From: forest kirst <[REDACTED]>
Sent: Monday, November 28, 2016 9:09 PM
To: Gunther Todd
Cc: forest kirst
Subject: ANC 14LA068 N-4827K

RE: Navion N 4827K crash 09/24/2014 Atigun Pass Alaska

Re: Navion Propeller and Clamp pictures you shared

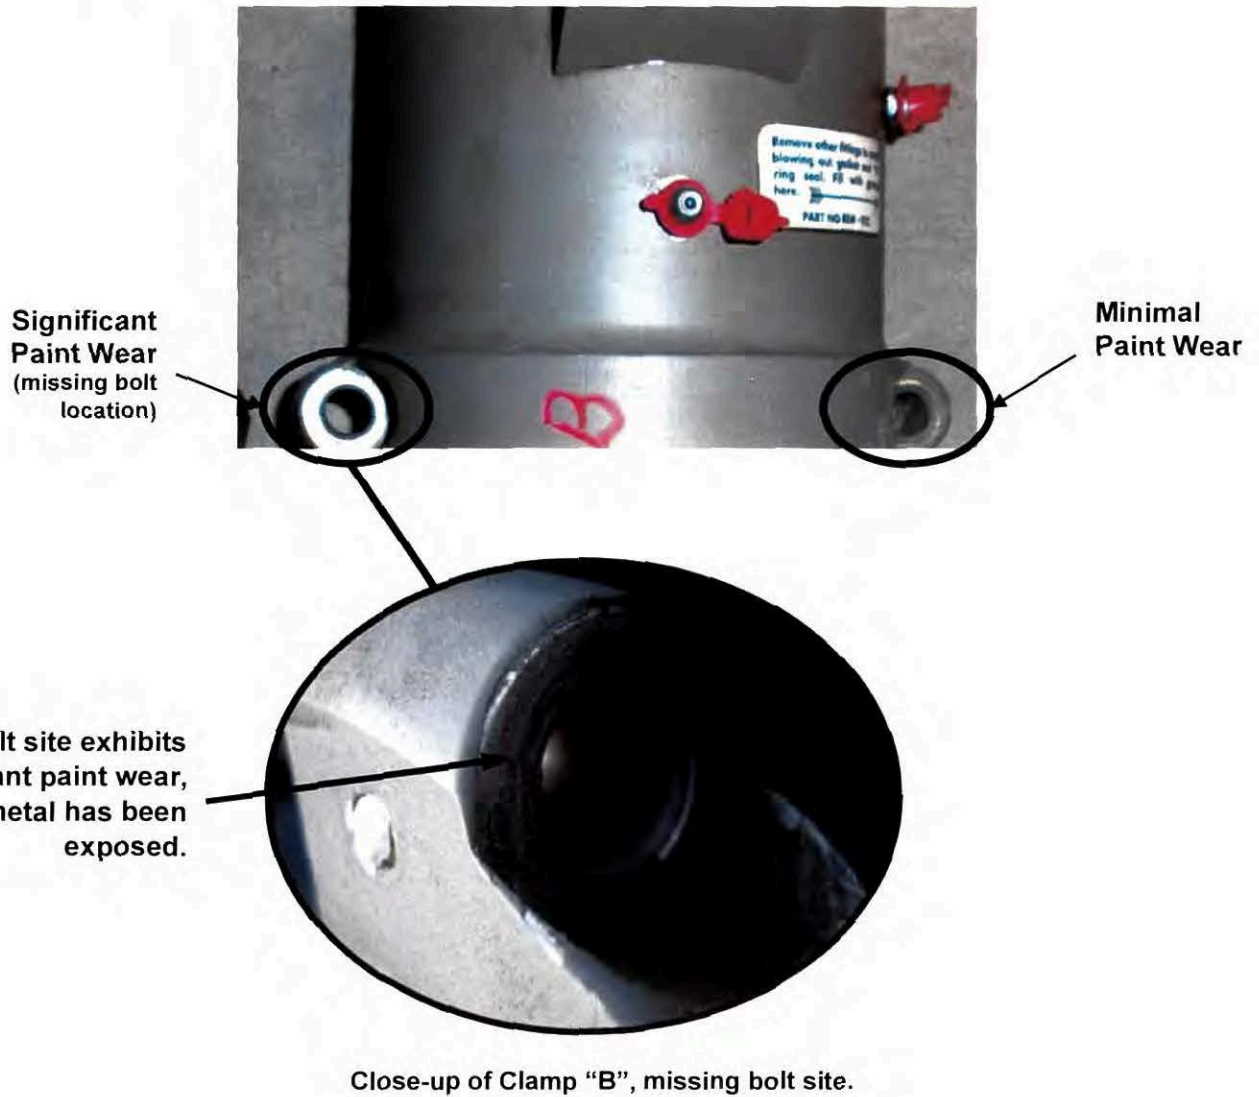
The propeller clamp, indicated "B" below, was reported to have one of the two mounting bolts missing at and around the crash site. This bolt has not been found to date.

It is evident that at lower-right bolt location on propeller clamp "B" that the paint wear was limited. The location at the lower-left exhibits exposed metal, indicating that this interface has been exposed to significant relative motion (sliding motion) under the bolt or nut. This would be caused by insufficient bolt preload, that is, a loose bolted joint. The bolt at this location has not been recovered to date. This indicates that significantly higher bolt preload existed at this bolt location.

Based on the pictures of the propeller clamp, the missing paint at the bolt interface indicates that the propeller clamp bolt at location "B" did not have sufficient preload. This could be due to either insufficient (low) installation torque or torquing the bolt past the yield point (too much torque), both of which could cause bolt failure during flight. The bolt backing out during flight vibration would be expected and may explain why the bolt has not been recovered to date.

FIGURE 6-1. ENGINE MOUNT AND COWLING

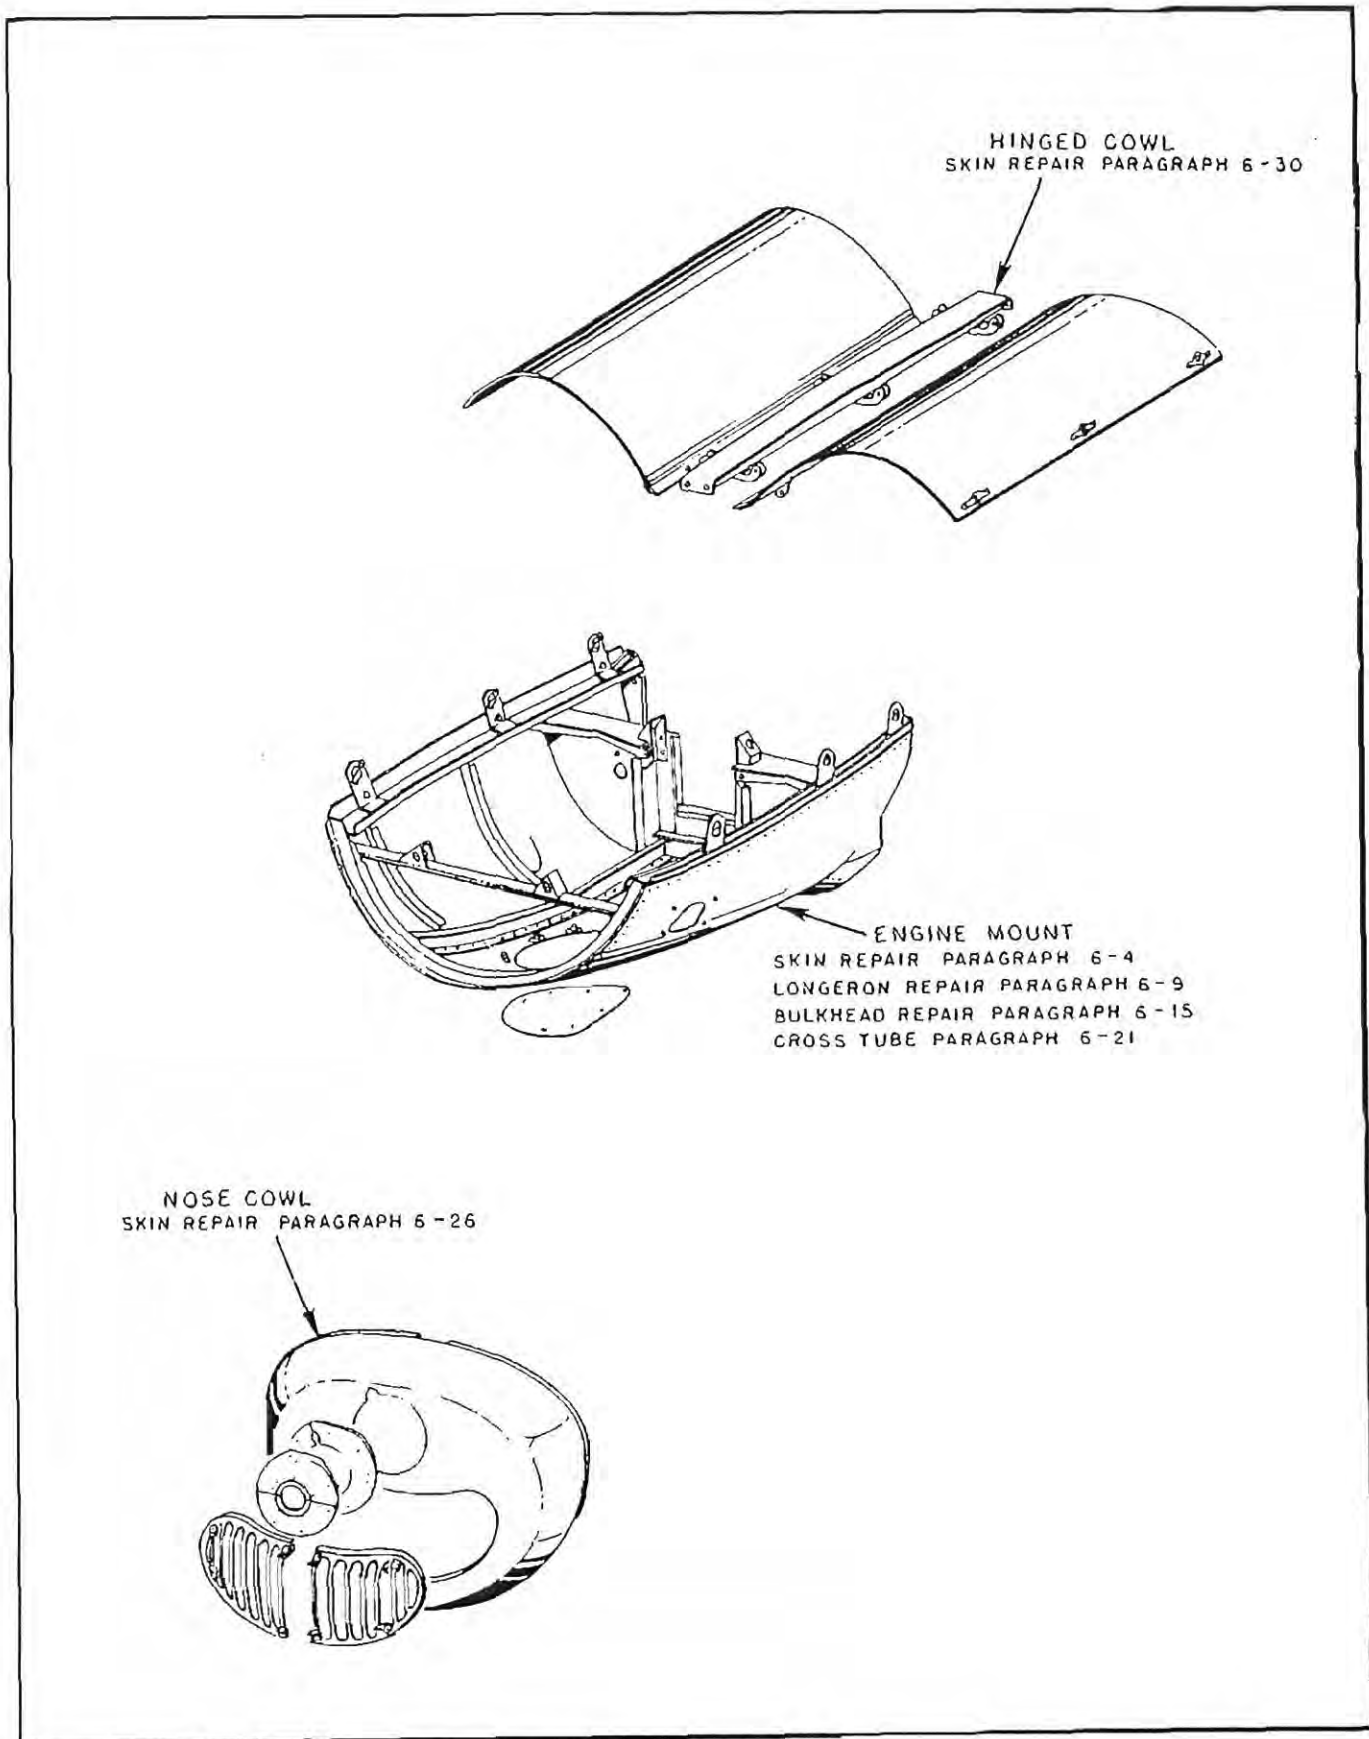
In photos of the left side of the aircraft taken at the landing site it is evident that the entire lower motor mount has detached from the aircraft. This can be verified by checking against the navion Structural repair manual. This is consistent with propeller failure.
